Appl. No. 10/204,331
Response dated March 9, 2005
Reply to Office Action of November 9, 2004

REMARKS

Fig. 1

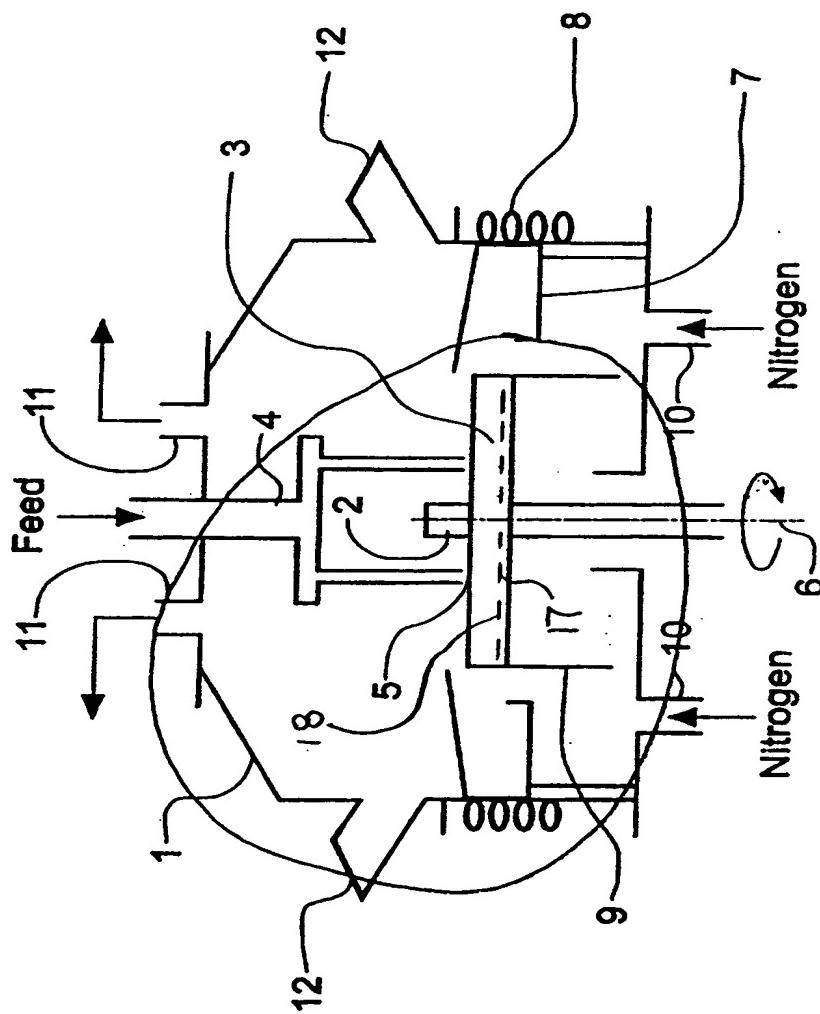
The drawings were objected to as failing to show element 18 as described in the specification. Applicants have amended Figure 1 to show element 18. Reference numeral 17 has also been added to Figure 1. Both annotated and replacement drawing sheets have been included with this response.

The attached sheet of drawings includes changes to Figure 1. This sheet, which includes Figure 1, replaces substitute sheet (Rule 26) 1/3 as entered in the U.S. national stage. In Figure 1, reference numerals 17 and 18 have been added. The added dashed line (to which reference numeral 18 is attached) indicates shear member 18. Reference numeral 17 indicates thin film 17. An annotated sheet showing the changes has also been submitted.
